# Notice of Modification

The project approval (08\_0101) granted by the Minister for Planning on 26 November 2010 for the Integra Underground Project.

### APPENDIX 3: PROJECT LAYOUT PLANS

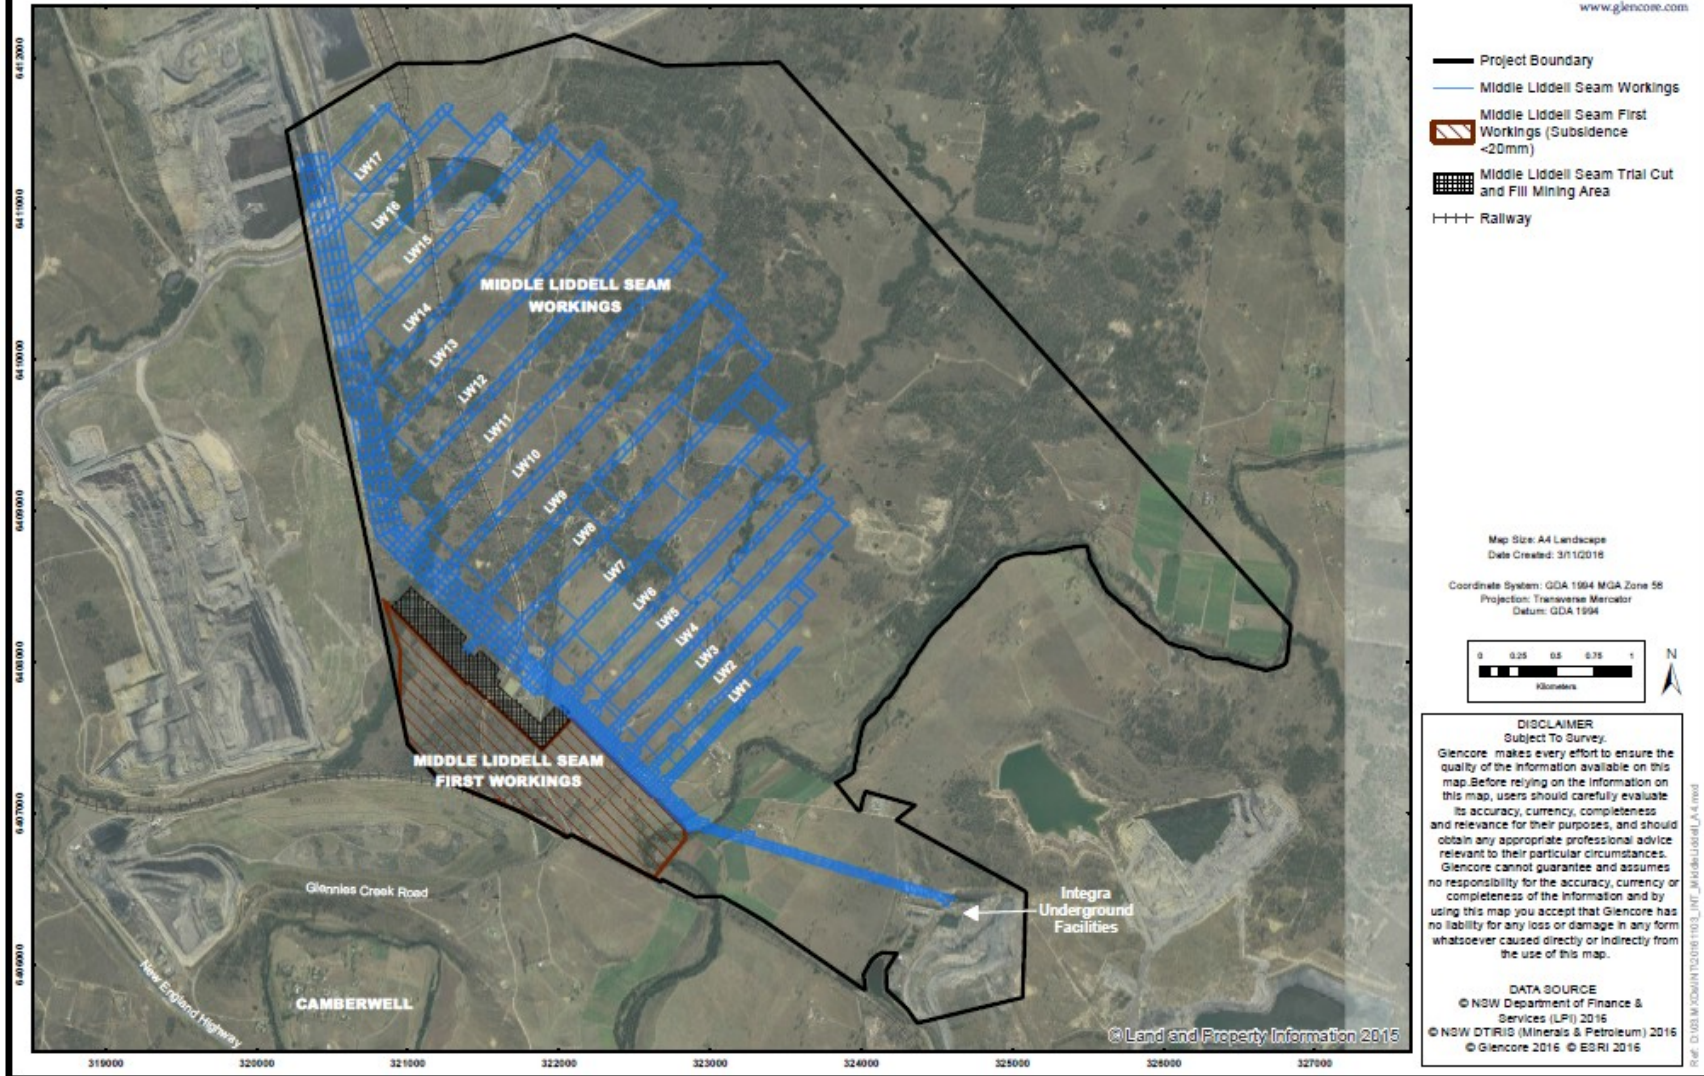
8. Delete Appendix 3 and replace with the following:
